ADDENDUM NO. 1

METROPOLITAN SEWERAGE DISTRICT MSD ITT PUMP STATION REPLACEMENT

MSD PROJECT NO.: 2020061

ADDENDUM ISSUE DATE: JULY 9, 2026

ITT PUMP STATION REPLACEMENT
CIVIL
GRAVITY SEWER PLAN AND PROFILE
STA. 0+00 - STA. 9+31

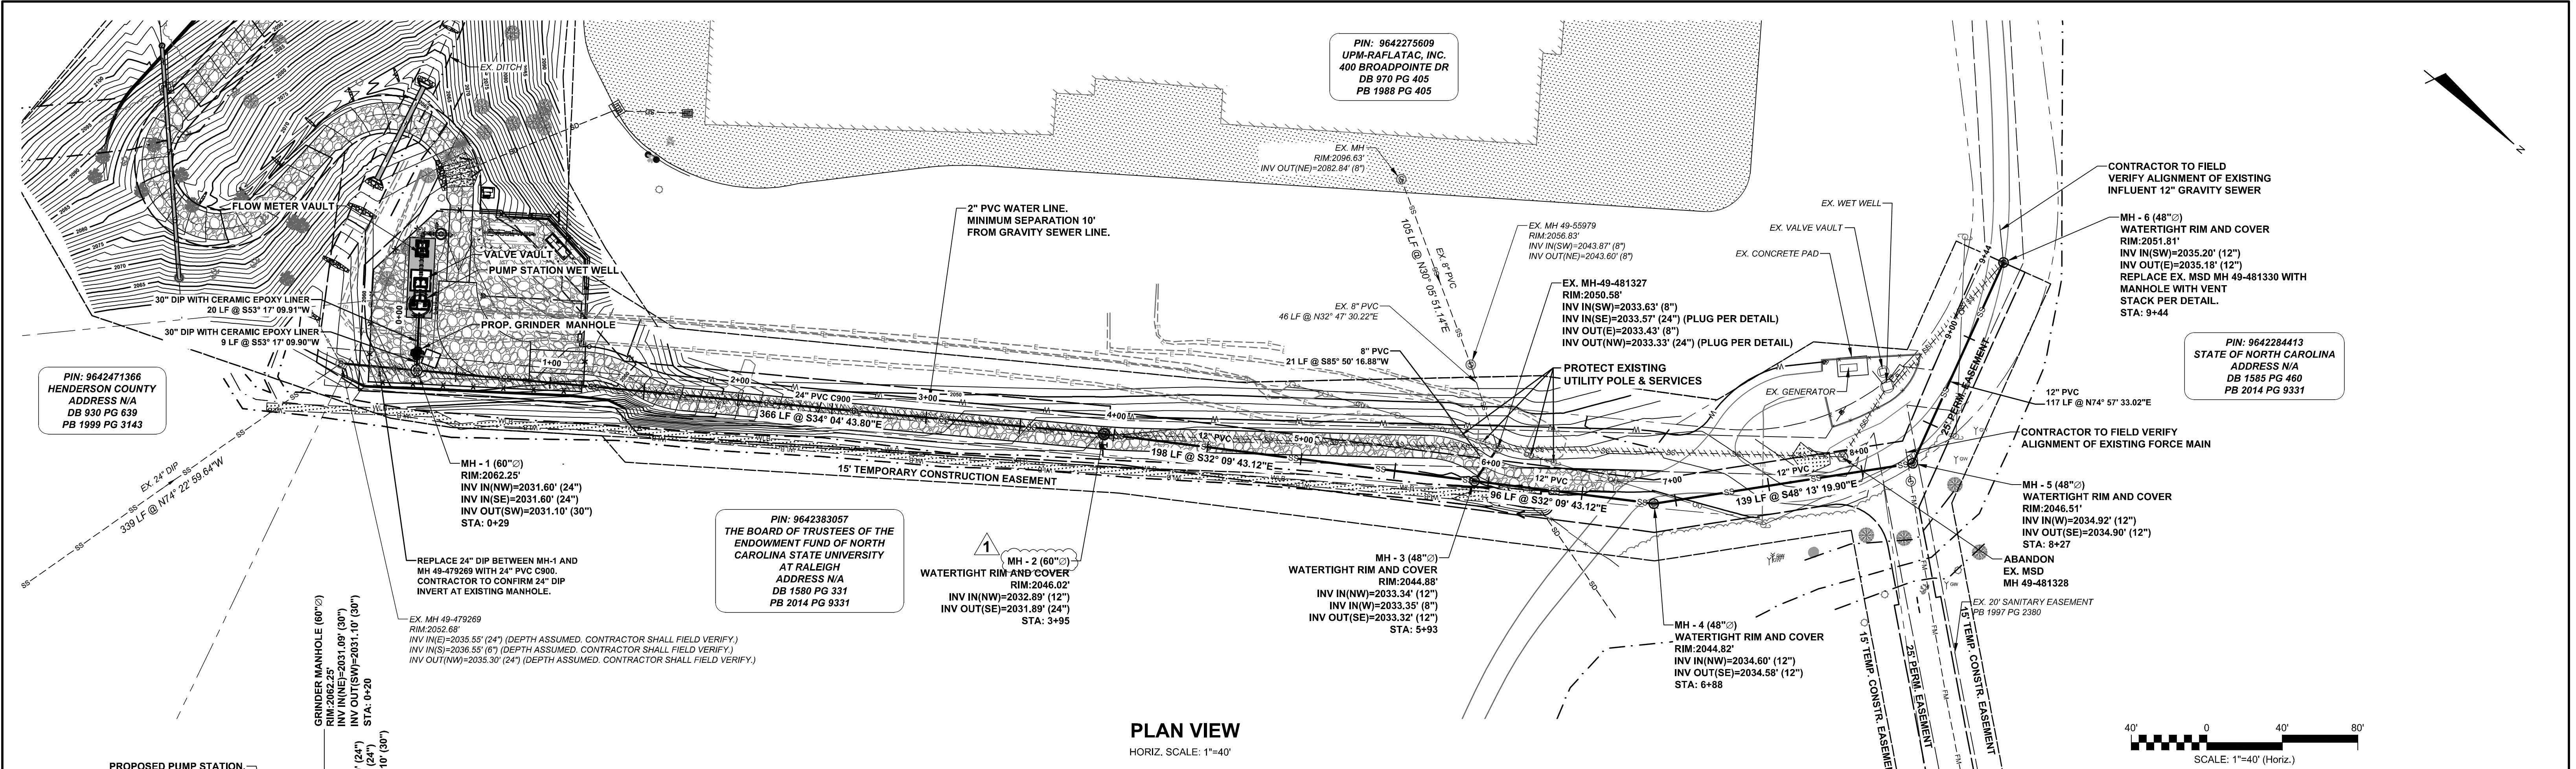
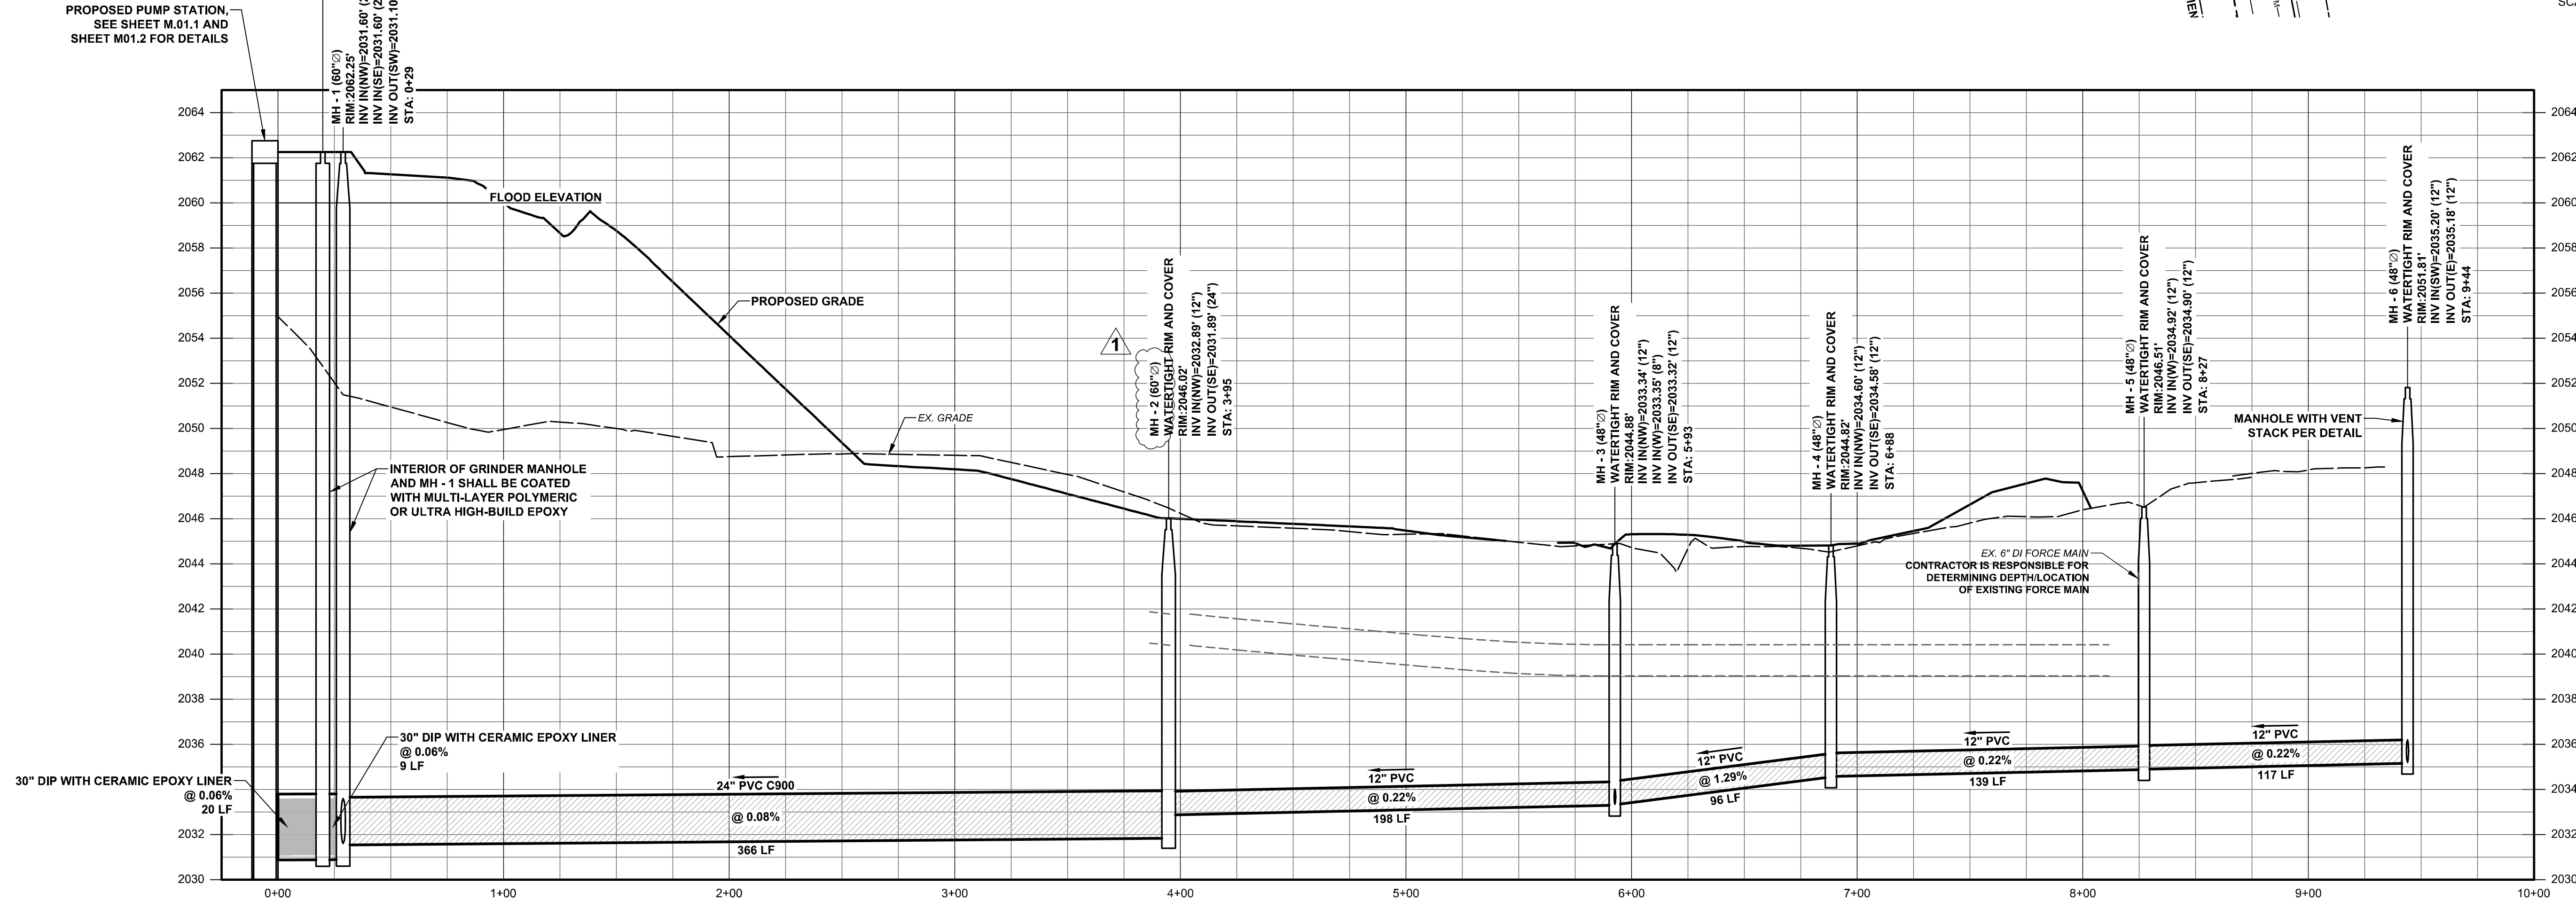
1. Replace drawing CU04.1 with the revised drawing CU04.1 attached to this Addendum No. 1.
2. Replace drawing CU05.1 with the revised drawing CU05.1 attached to this Addendum No. 1.

PROPOSED SITE PLAN

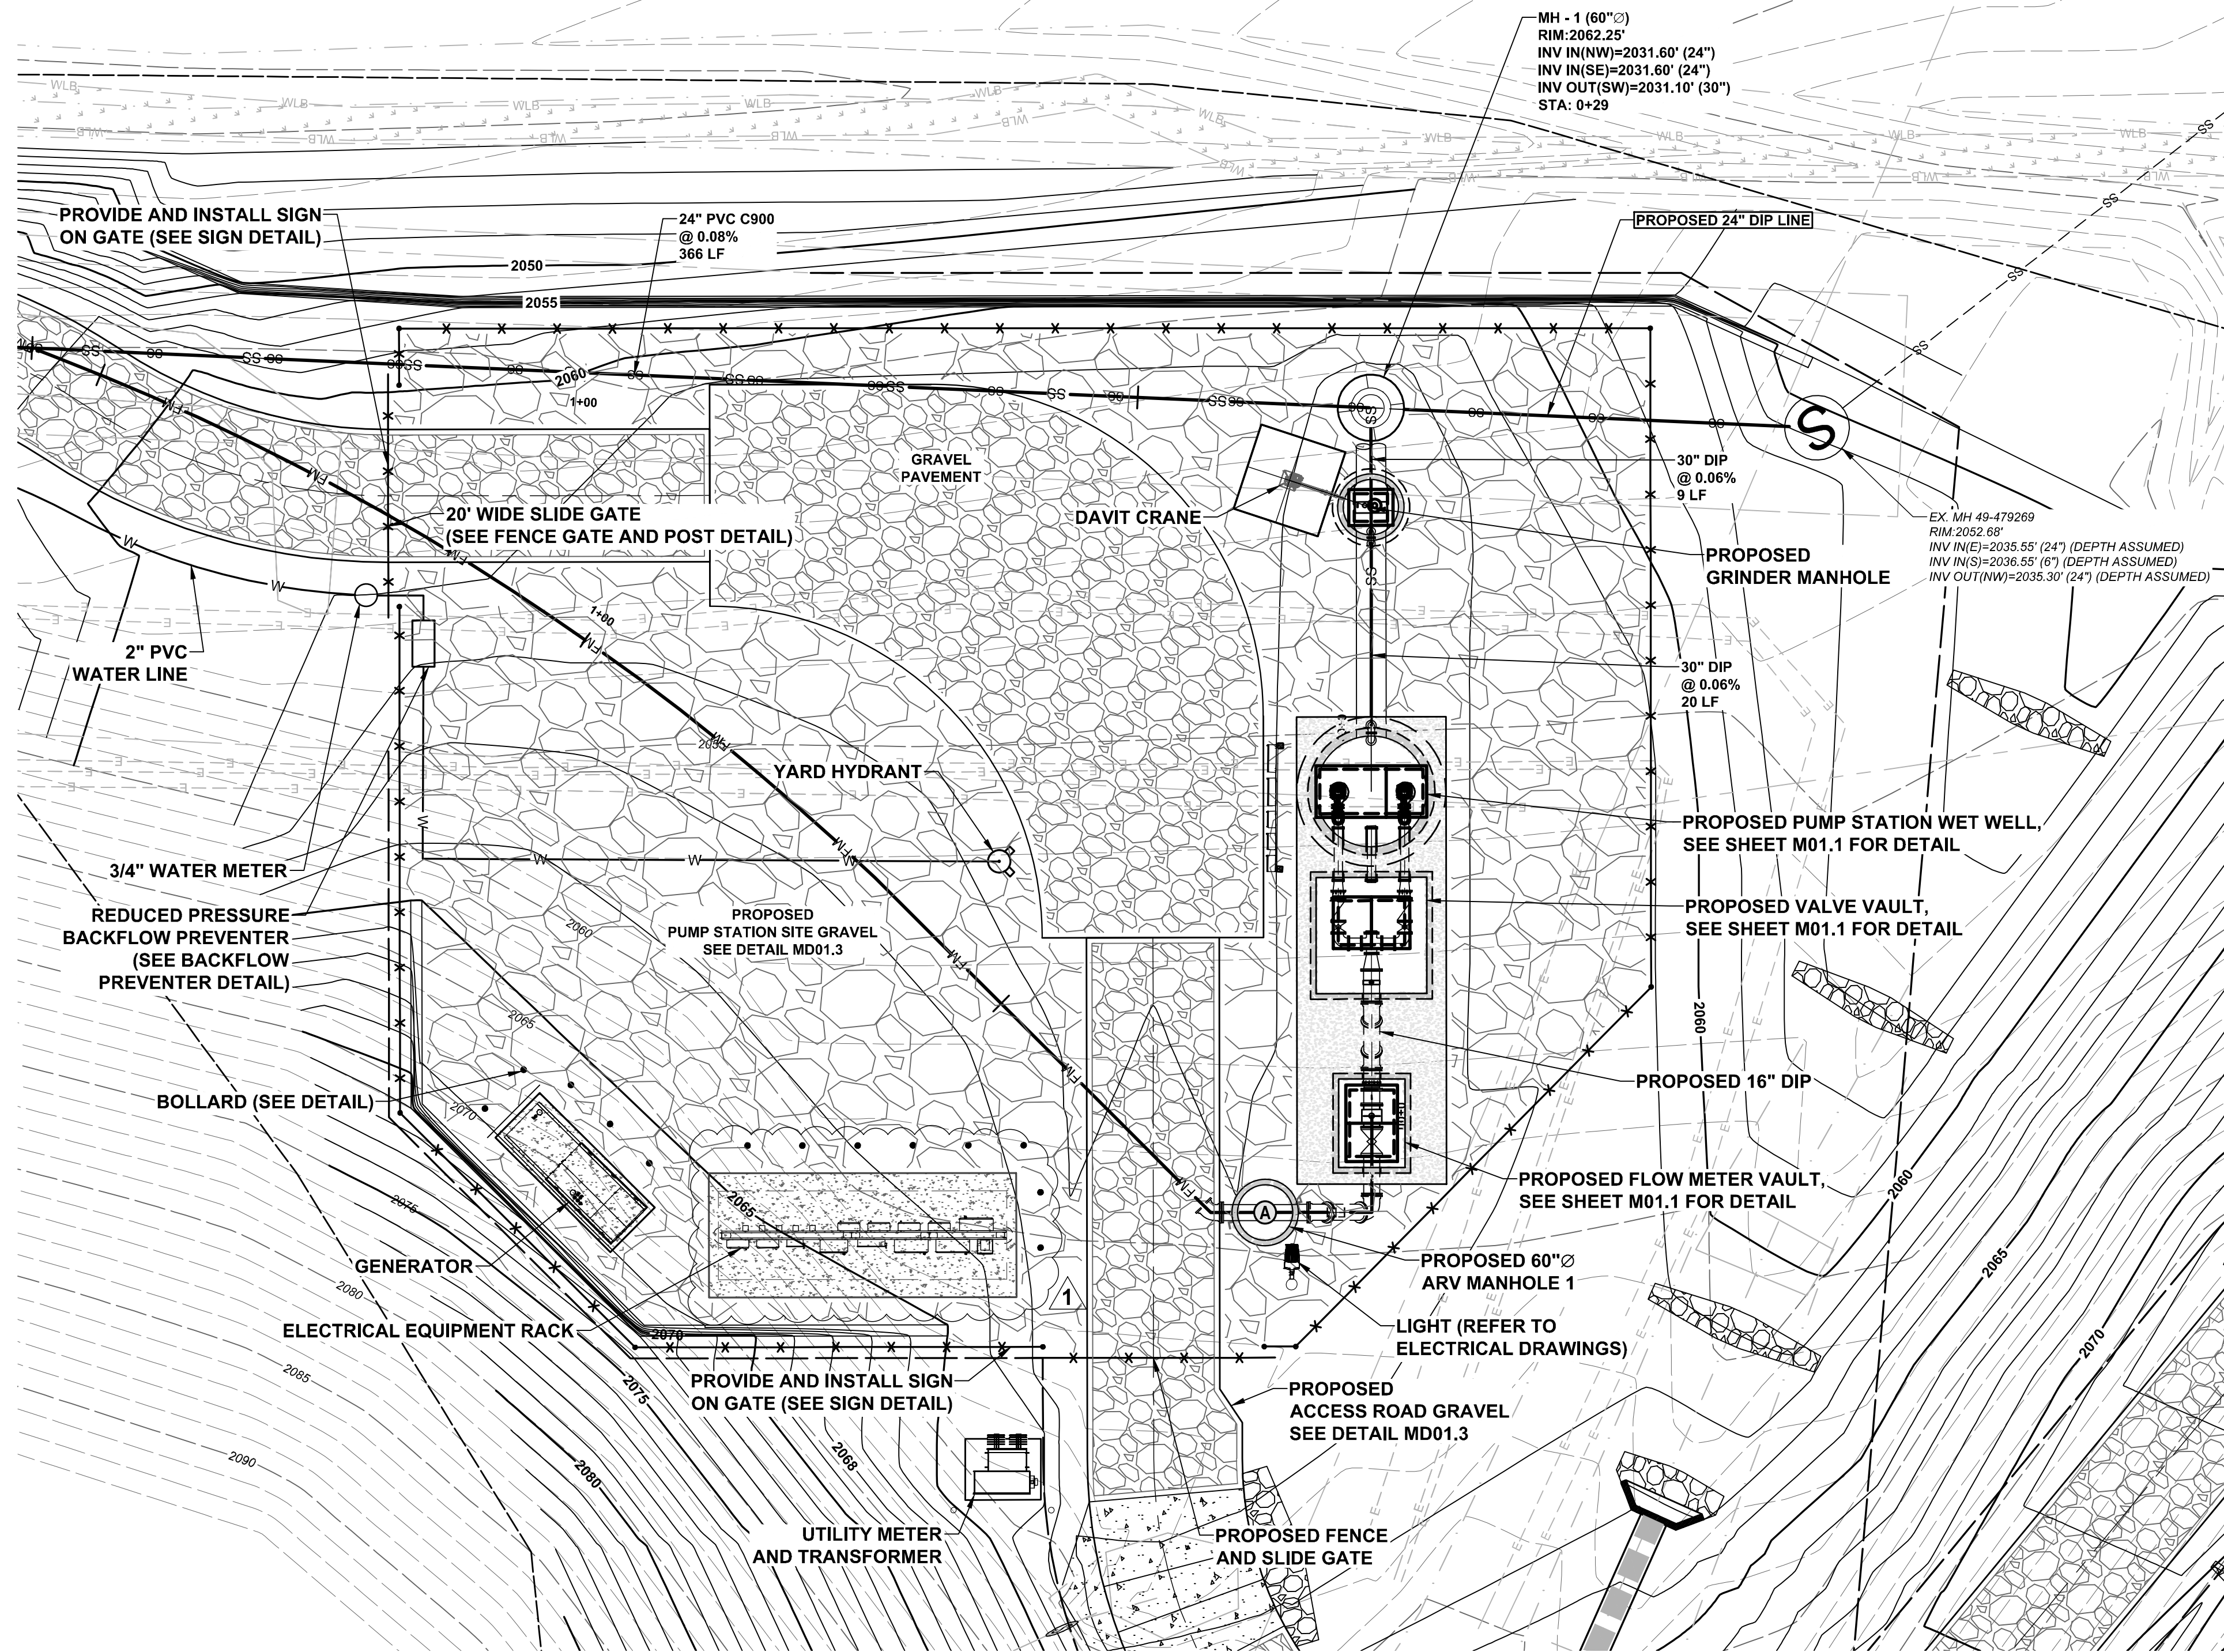
3. Replace drawing CS01.1 with the revised drawing CS01.1 attached to this Addendum No. 1.
4. Replace drawing CS02.1 with the revised drawing CS02.1 attached to this Addendum No. 1.
